INSTRUMENT APPROACH CHART

RJCO / SAPPORO RNP Z RWY14

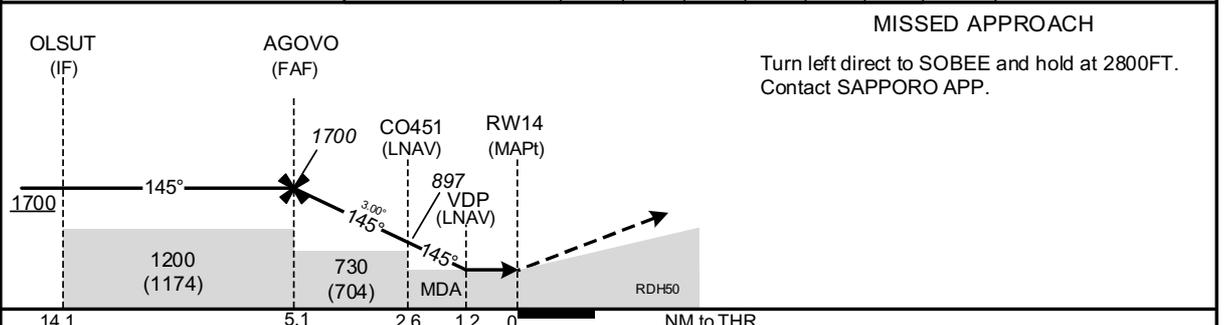
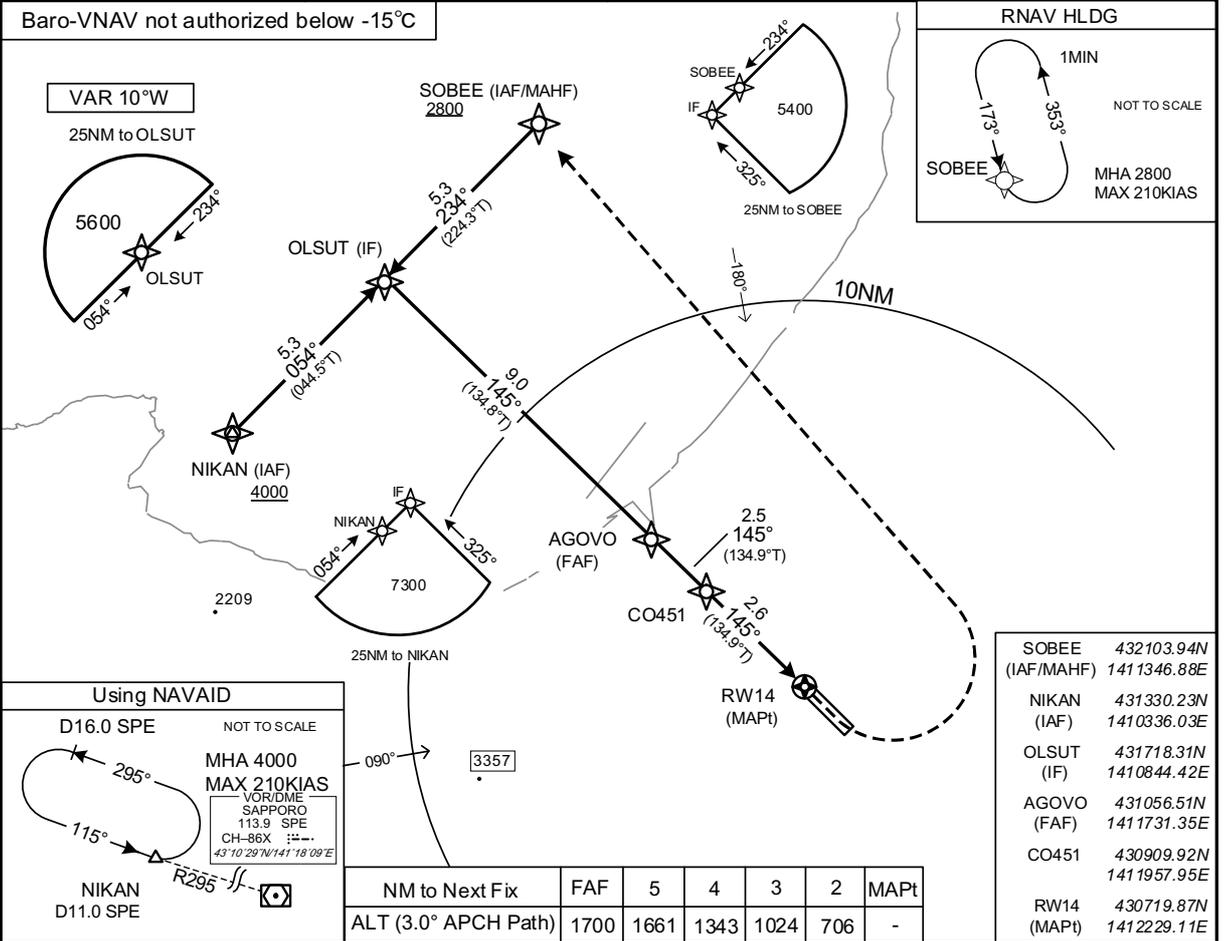
CHANGE : OCA(H) FM OLSUT to AGOVO. Missed APCH for using VOR/DME abolished. HLDG pattern for using NAVAID (SOBEE) abolished.
